**BEFORE THE PUBLIC UTILITIES COMMISSION
OF THE STATE OF CALIFORNIA**

Rulemaking 18-10-007
(Filed October 25, 2018)

**COMMENTS OF THE UTILITY REFORM NETWORK ON 2021 WILDFIRE
MITIGATION PLAN UPDATES**

March 29, 2021

Figure 1– 2020-2022 WMP Spending Per Customer for Large Utilities³³

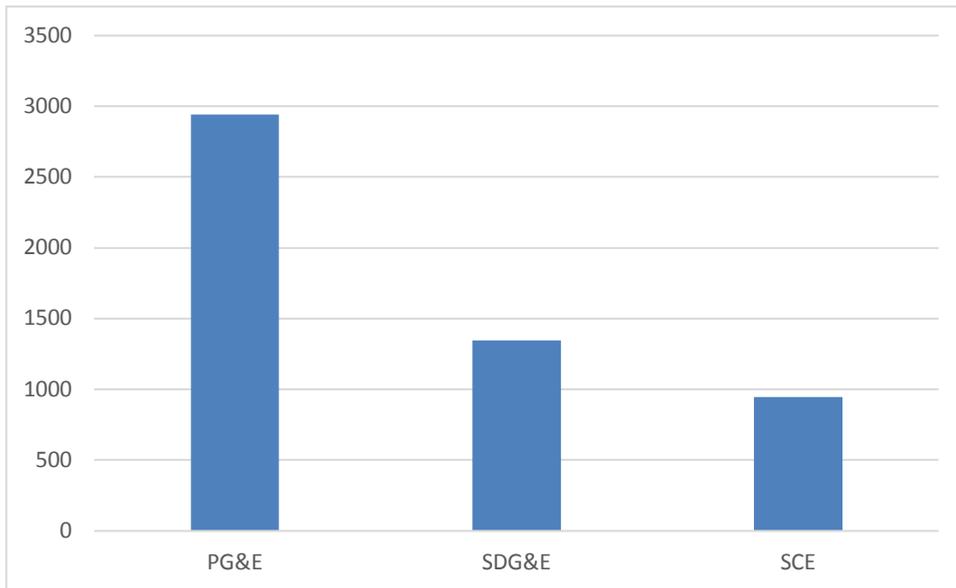
With respect to total WMP spending for 2020-2022 (recorded and planned), PG&E’s per customer spending significantly exceeds that of Southern California Edison (SCE) and San Diego Gas and Electric (SDG&E), as shown in the figure below.

Thus, PG&E is on pace to significantly outspend its peer utilities even taking into account differences in utility size, miles of overhead other facilities, and prevalence of red flag warning conditions.

Figure 2: Annual Ignitions by Driver, PG&E, Average for 2015-2020⁹⁴

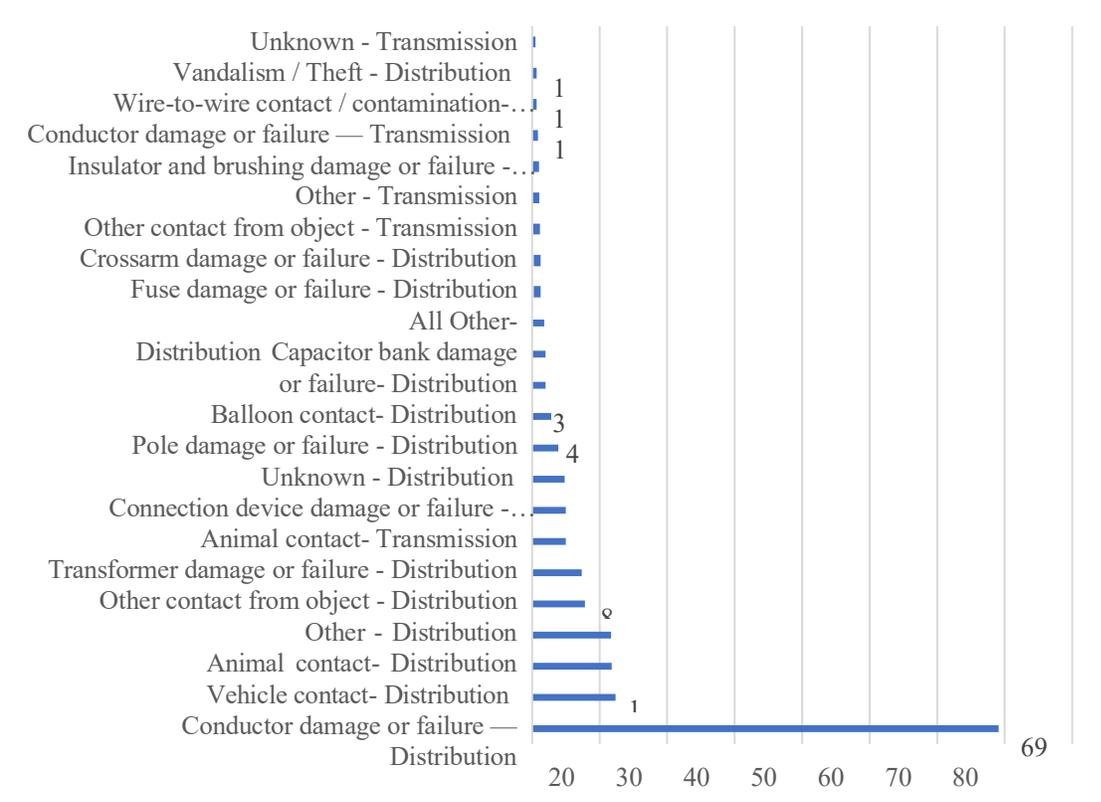
As shown in the Figure, the failure of assets such as fuses, crossarms and poles causes less than three ignitions per year. Reclosers and switches caused zero ignitions from 2015-2020, yet PG&E replaces them under overhead hardening guidelines.⁹⁵ Moreover, all transformers are exempt,⁹⁶ so there is no apparent justification for wholesale replacement of transformers. Calculations presented in the RAMP proceeding illustrate that the RSE for crossarms and transformers is a factor of ten lower than the RSE for covered conductor or fuses/switches.⁹⁷ The bottom line is that PG&E has devised a completely new design standard for its HFTD

Figure 3: SCE Risk Curve¹²²

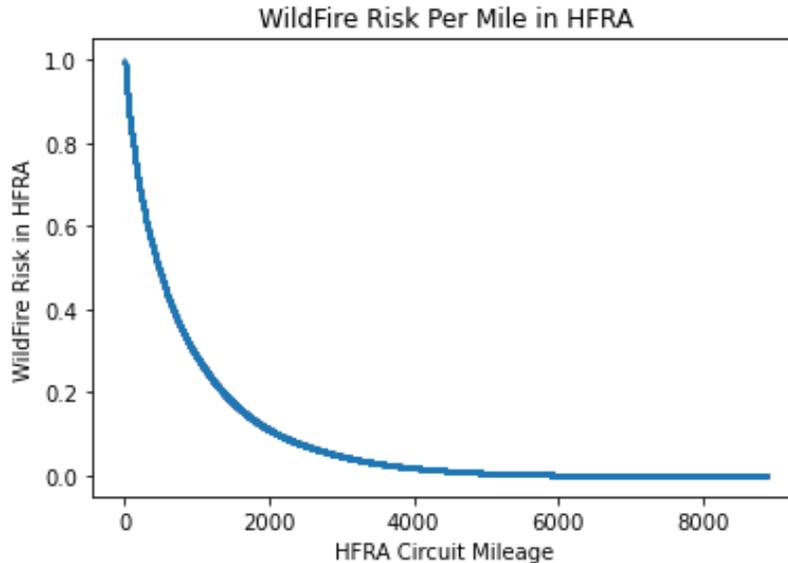
The horizontal axis of the curve shows cumulative HFRA circuit miles and the vertical axis “represents the sum of all the wildfire risk in terms of both probability of ignition and consequence for circuit segments in the HFRA.”¹²³ The risk curve is steeper from 0-2,000 HFRA circuit miles, when it begins to flatten out, meaning that risk is more concentrated in the first 2,000 HFRA circuit miles. As shown by the arrow in the figure above, SCE’s proposed scope of covered conductor during the WMP term would address risk after the risk curve begins

Ex. TURN-02 Figure 5 Wildfire Risk v Cumulative HFRA Miles; SCE GRC Risk Analysis²⁹⁰

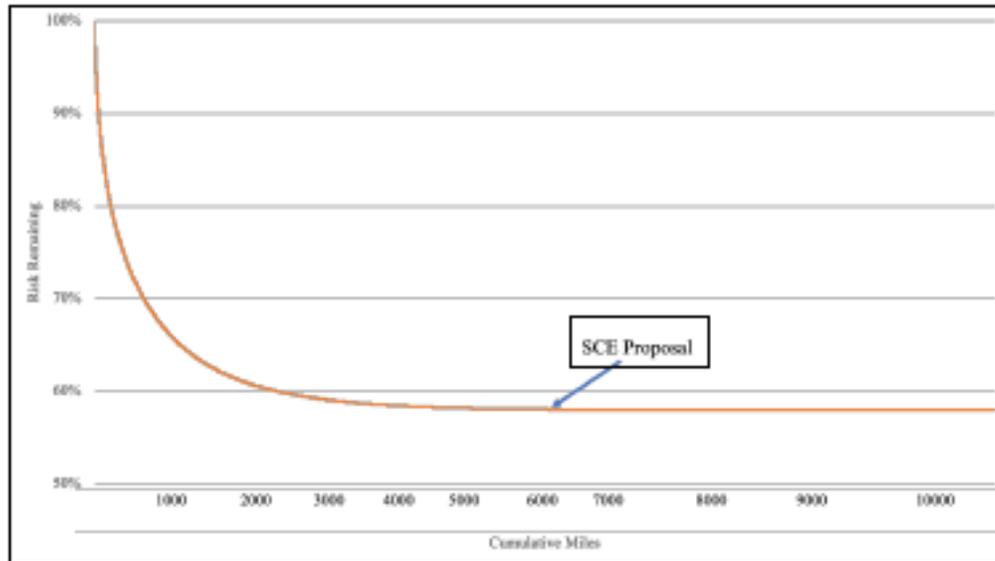
The steep decline in Ex. TURN-02 Figure 5 demonstrates that SCE’s highest risk segments are fairly concentrated. As the slope begins to flatten, each additional mile is less risky on a relative basis. TURN’s proposed program focuses ratepayer spending on those circuits that present the most risk.

Ex. SCE-15, Vol. 5: Figure II-3 Overlay of Historical Large Fire Events on SCE's Relative Risk Buydown Curve³¹⁴

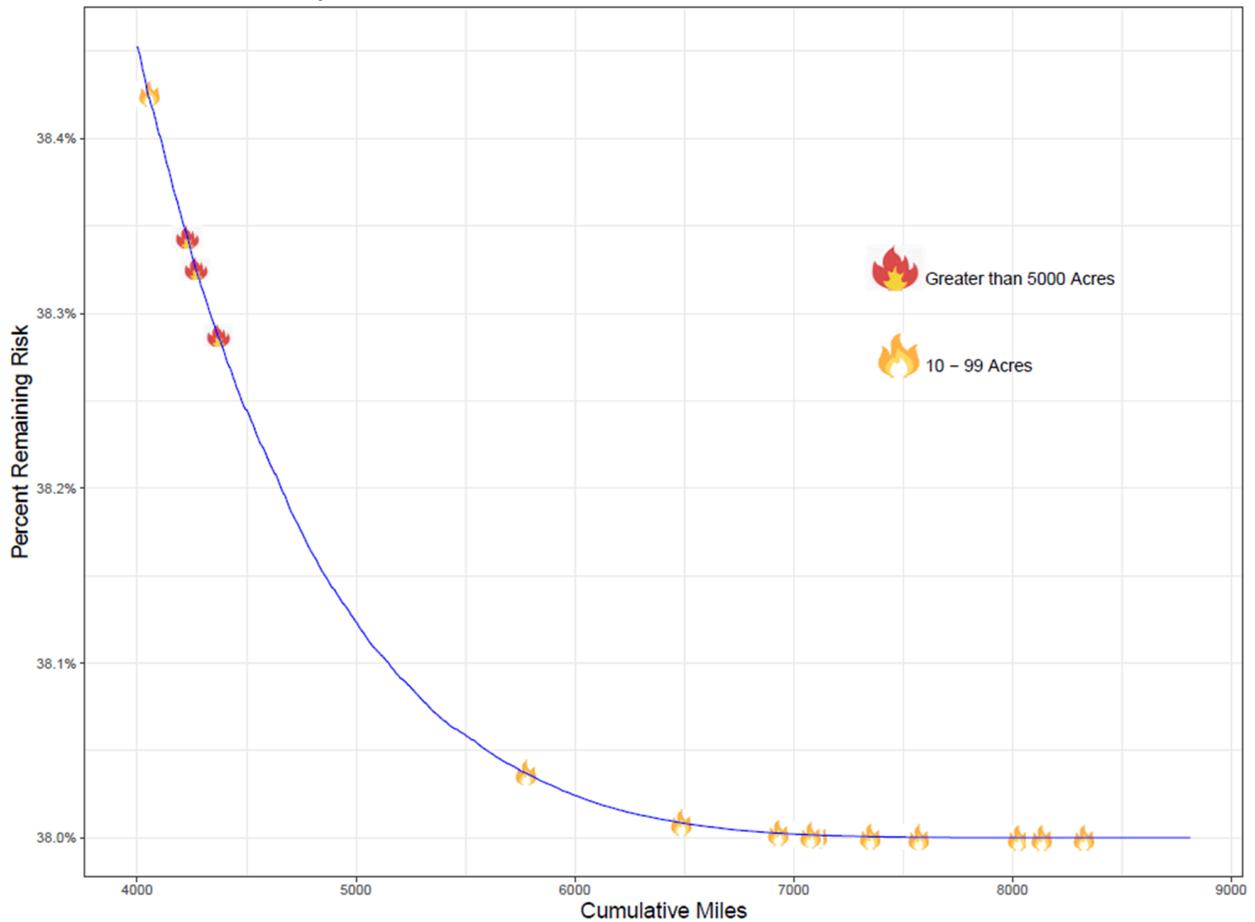
As an initial matter, and for purposes of clarification, each fire icon represented in the figure does not necessarily represent a separate fire, each icon instead represents an impacted circuit.³¹⁵ Figure II-3 reflects two fires greater than 5,000 acres and seven fires impacting between 10 and 99 acres.

efficient use of ratepayer dollars consistent with just and reasonable rates to deploy covered conductor to circuits at such relatively low points in the risk buydown curve. TURN fully expects other wildfire risk mitigations to be deployed here, as discussed above. As the y-axis of SCE's Figure II-3 demonstrates, the circuits shown represent between 38 and 38.5 percent of remaining wildfire risk. In other words, TURN does not believe it is just, reasonable, necessary, or efficient to spend \$421,000 per circuit mile to potentially buy down less than 0.5% of remaining wildfire risk. SCE's Rebuttal demonstrates the utility has effectively ignored affordability constraints in lieu of arguments that ratepayer funds must be expended subject only to the limits of SCE's resources.
